Subject: RE: 2021-1952: TDC Growth Plan Change - Waka Kotahi reverse sensitivity feedback

Subject: 2021-1952: TDC Growth Plan Change - Waka Kotahi reverse sensitivity feedback

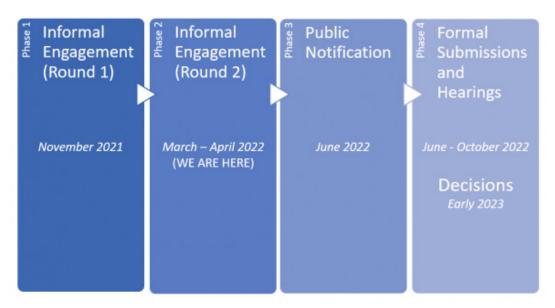
Following on from our earlier correspondence regarding Tasman District Council's growth plan change – We have now refined the growth plan change areas, and have developed our thinking around intensification of the sites, based on the early feedback received and the available infrastructure and constraints information. You can see the latest growth plan change areas, and what is proposed for each site, on Council's website – https://www.tasman.govt.nz/my-council/public-consultation/current-consultations/growth-plan-change-feedback/

You have previously advised that reverse sensitivity needs to be considered for the Brightwater site. We have taken this into consideration and are looking at applying site-specific noise mitigation rules. This is currently just the staff
